Re: SHPO Project Number: 18PR07273 (For Generic), 21PR04693 (Supplemental)
National Historic Preservation Act (NHPA) – Section 106 Consultation
Albany Port District Commission Port of Albany Expansion Project
Beacon Island Property

Project Name: ENV#2642101 309 River Rd

Subject: Site Plan Review Comments received 11/17/2021

Re: Port of Albany Marmen-Welcon Manufacturing Facility: 309 River Road Fire Flow

Figure 1-Location Map

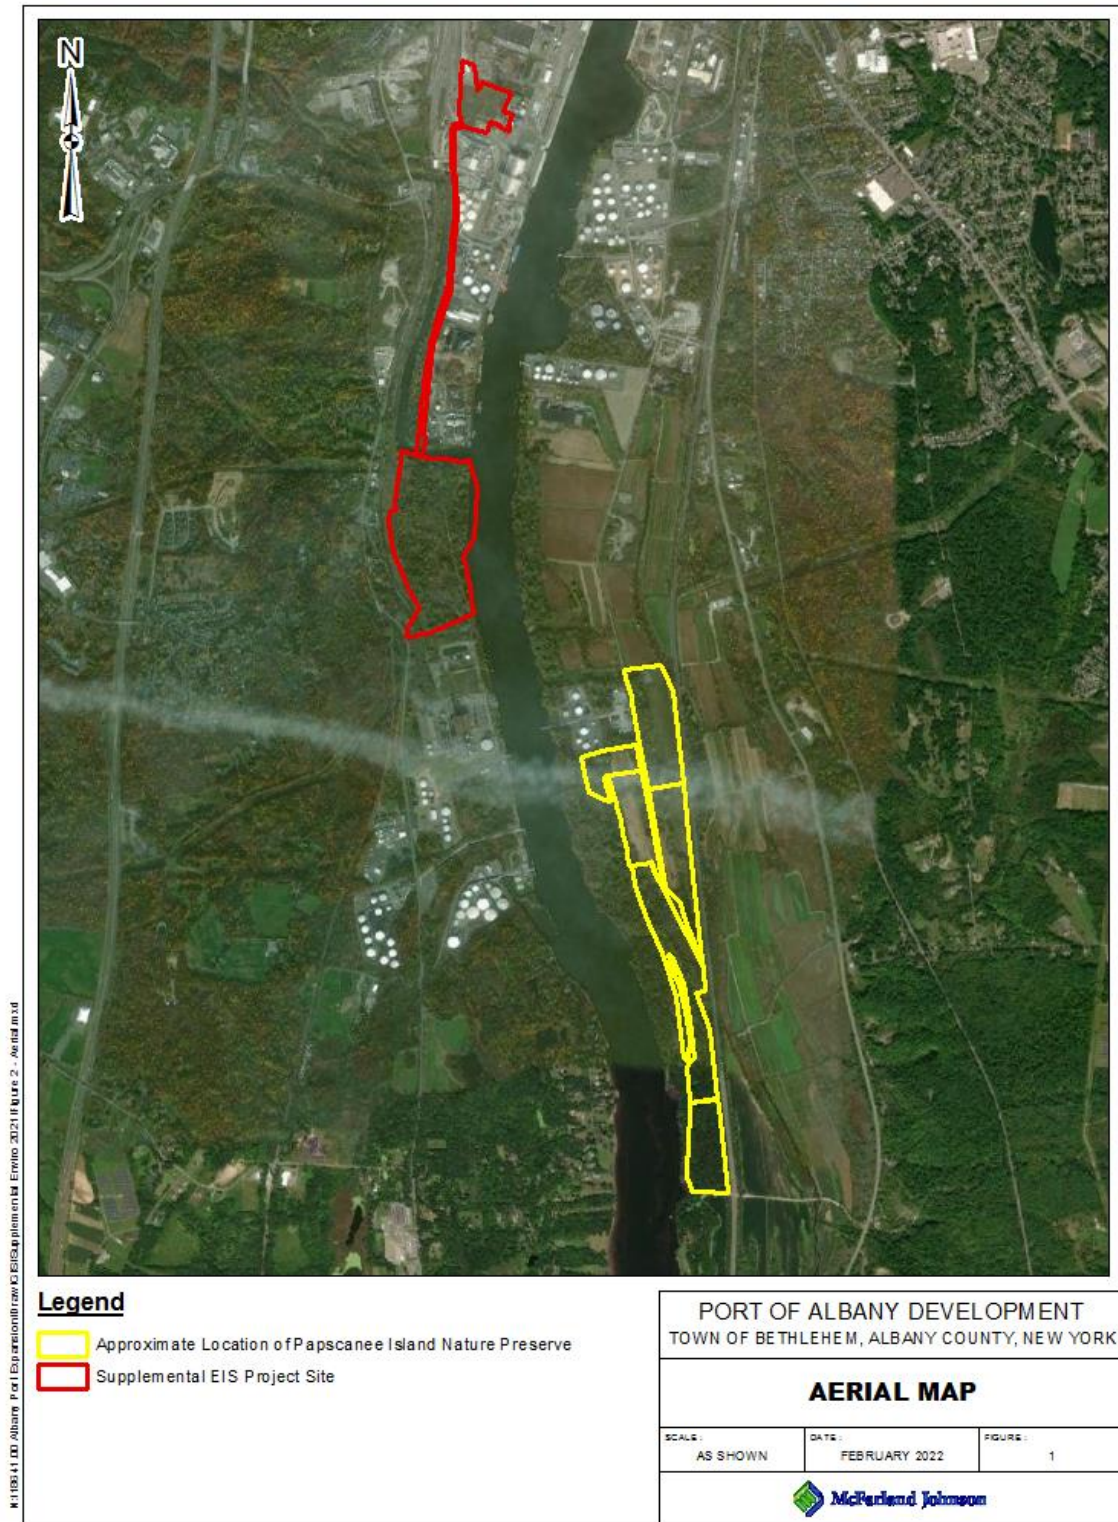
SMC THPO requests an acoustic noise assessment to be conducted that includes projected levels experienced from multiple points across Papscanee Island. This assessment should include ambient noise levels recorded from Papscanee Island as well as what would be projected operating decibels experienced from the Island

Baseline noise measurements were collected at three (3) locations: Across from the Existing Port Wharf (MS-1), American Oil Road (MS-2), and Papscanee Island Nature Preserve (MS-3), as shown on Figure 1 and accompanying photos (attached). Noise measurements were collected between the morning of Tuesday, January 18 and the afternoon of Thursday, January 20, 2022. Measurements were recorded every 1 minute at each of the locations. Noise descriptors measured at each location include Leq, L10, Lmin, Lmax, Lpk. Peak noise measurements (Lpk) recorded at each location are as follows:

The anticipated peak noise generated from this Project would not exceed the peak existing background noise at Papscanee Island Nature Preserve or along the portion of Papscanee Island that is across the Hudson from the project site, and therefore, the Project would not have an adverse effect on noise. The noise assessment has been included via email along with this executive summary.

Figure 3 - Vertical Shaft Turbine-Type Pump Installation in a Wet Pit (Figure A.7.2.2.2/NFPA 20)

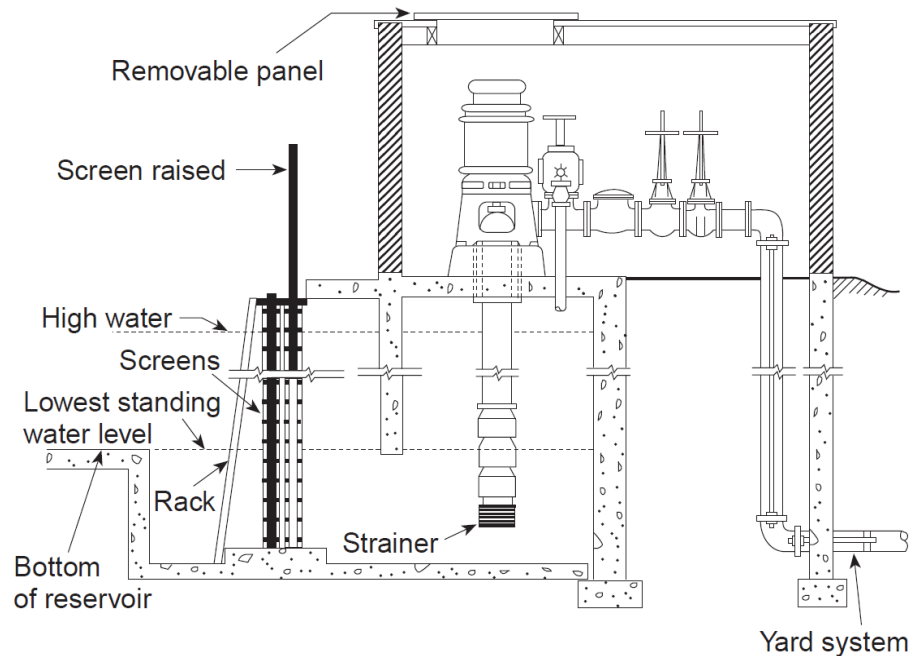
6. The enclosure will be supported on a concrete foundation with a wet pit right below it. The water for the pit will be provided by the Hudson River. The pit design will be similar to Figure 3 A.7.2.2.2 from NFPA 20, shown below:

7. The wet pit inlet will be protected by a pair of vertical screens that will protect the pumps from debris and fish entrainment. The screen will be sized such that the inlet velocity to the wet pit does not exceed the recommended velocities of 0.2 ft/s for a passive pump screen intake or 0.4 ft/s for an active pump screen intake (NOAA - Juvenile Fish Screen Criteria for Pump Intakes).

SP-00

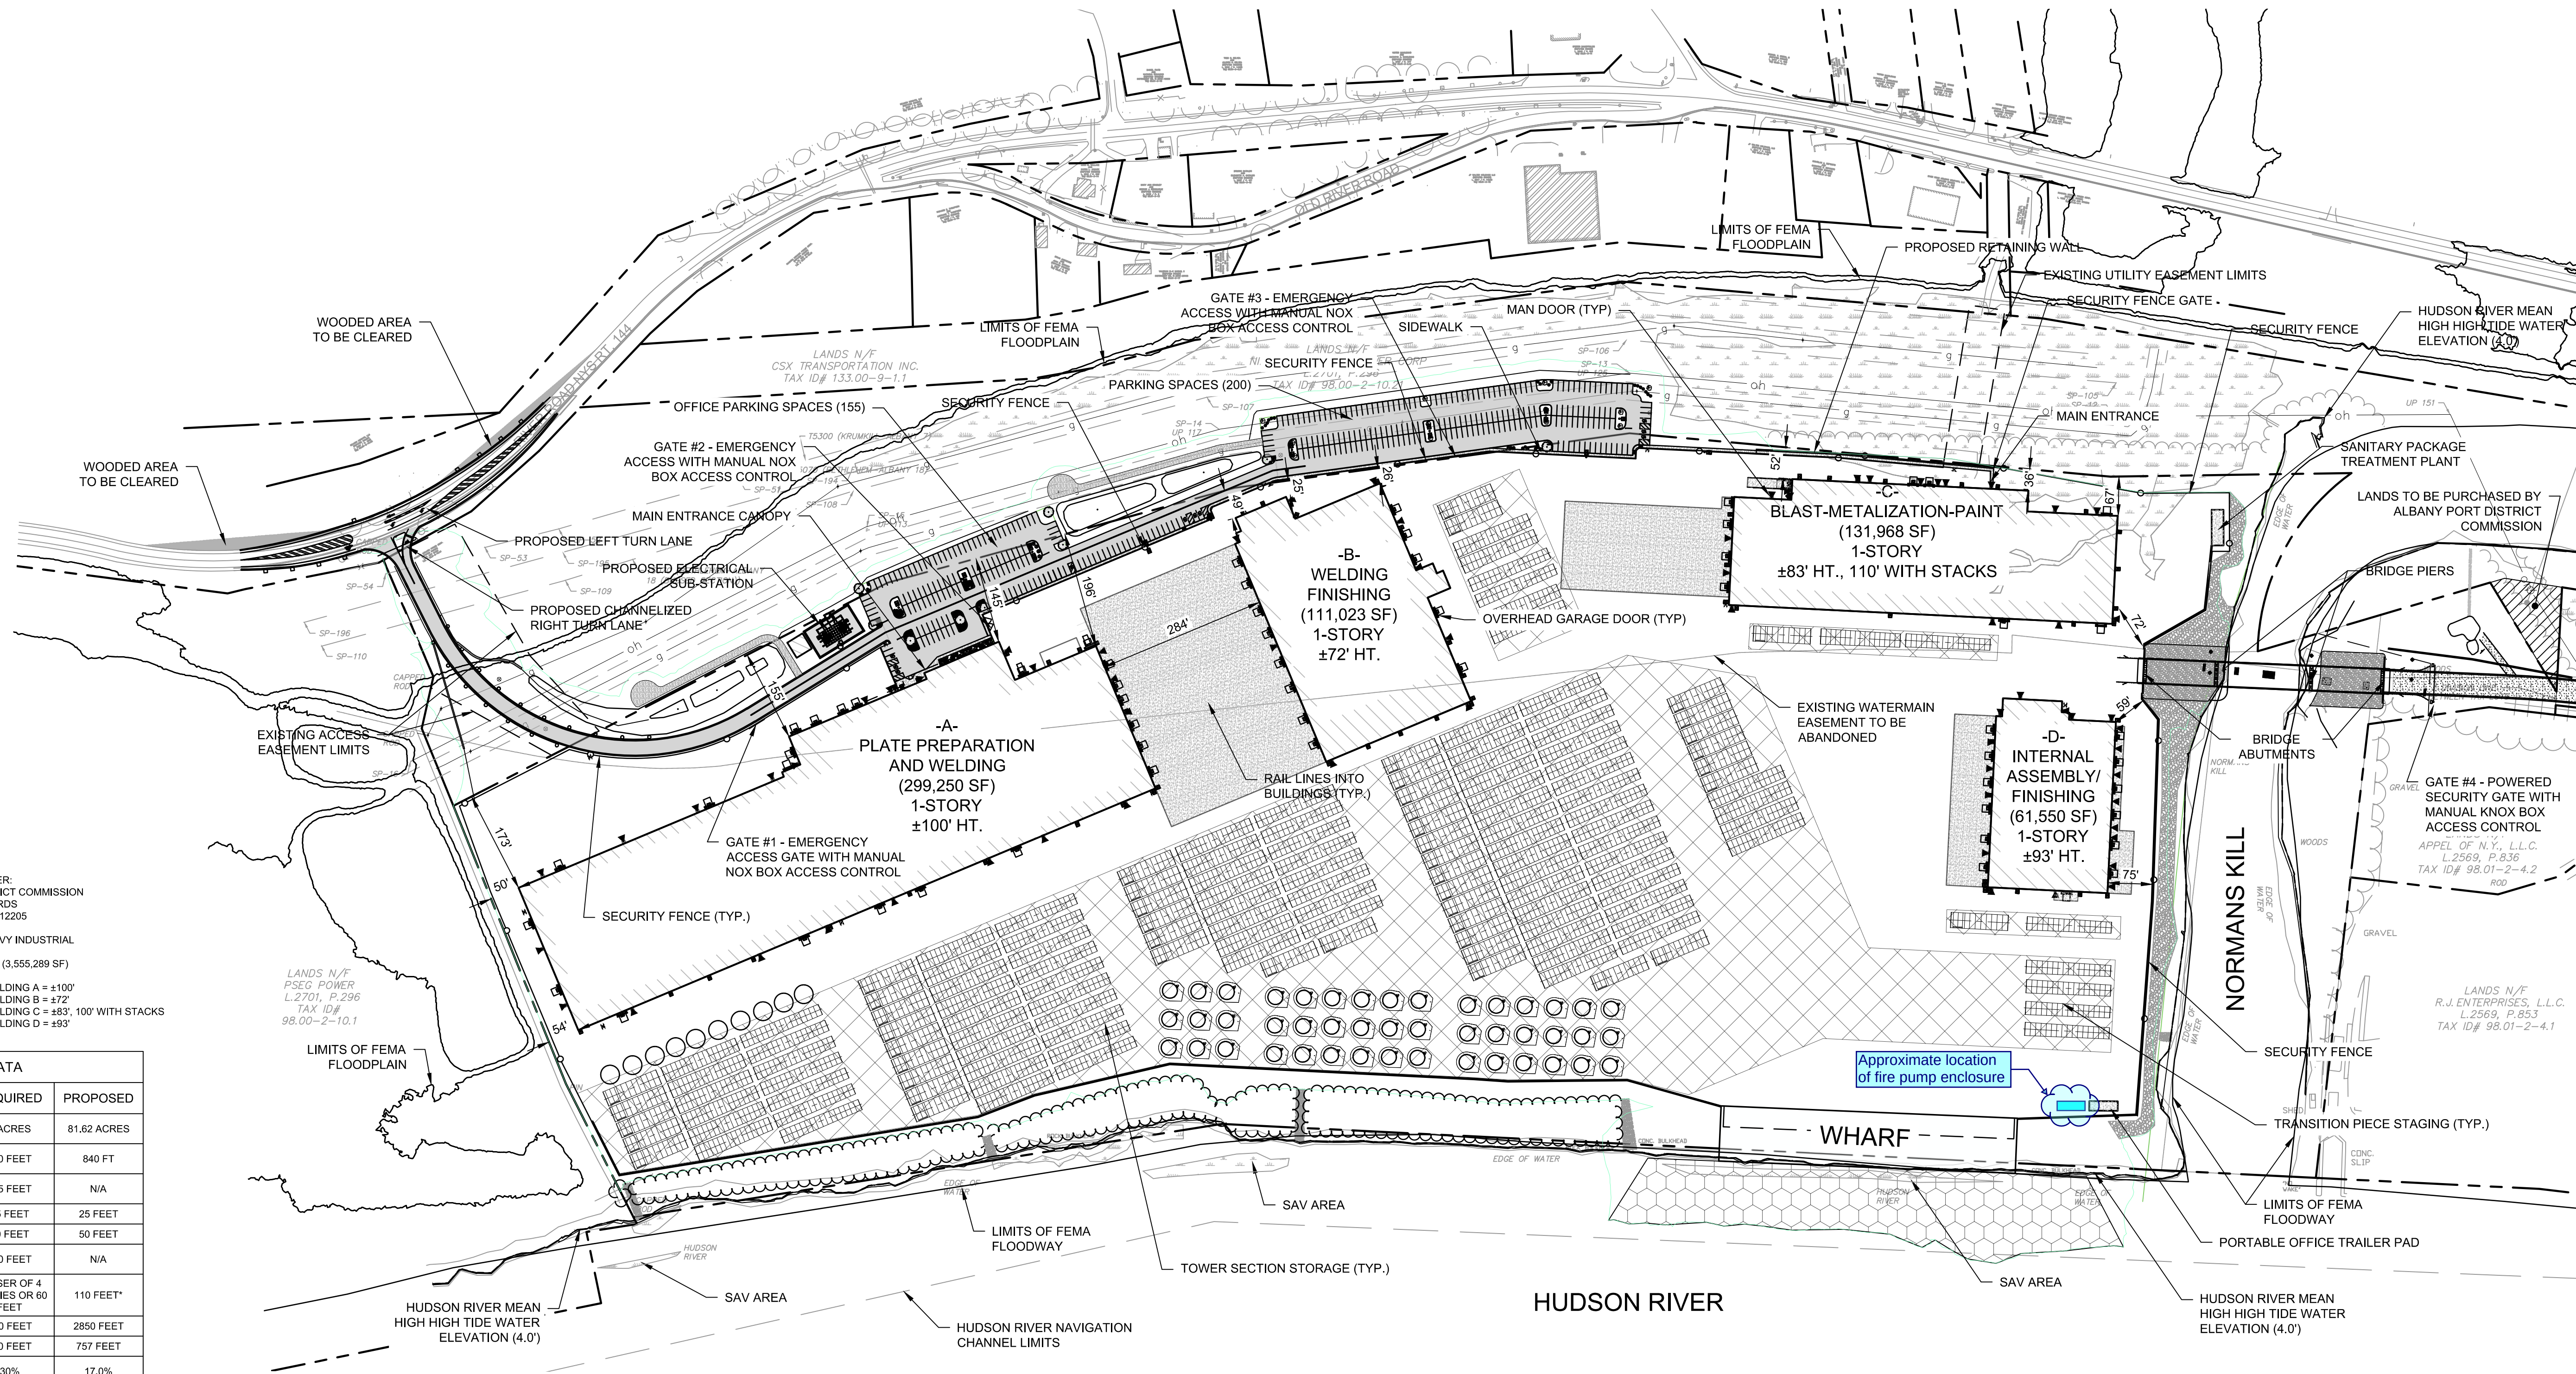
1. As detailed in the 1/7/22 letter the required site fire flow requirement is 2,000 gpm, consistent with the provisions of NFPA 1, Section 18.4 – Fire Flow Requirements for Buildings. The estimated fixed building fire sprinkler demand has been revised to account for building systems, that as of the date of this letter, have not been finalized (i.e. spray paint booths), as well as providing protection against shielded fires.

3. As detailed in the 1/7/22 letter the domestic demand is 20.5 gpm. Because the fire flow demand will be provided by the vertical turbine pumps, it is anticipated that the Town of Bethlehem need only satisfy the plumbing flow demand, which is well below the 1,250 gpm available at the 16-inch water main. A heated enclosure with the required backflow and water metering devices will be provided as previously planned. The domestic water line size may be reduced from the previously planned 10-inch connection to a 4-inch connection.

4. It is proposed that two Vertical Shaft Turbine - Type Pumps are installed over a wet pit that will draw water from the Hudson River as shown on the attached drawing SP-00. The pumps are preliminarily sized at 2,500 gpm each and will provide the necessary flow for the site hydrants as well as the fixed building fire sprinkler demand. The final pump selection will be determined once all the building components are finalized.
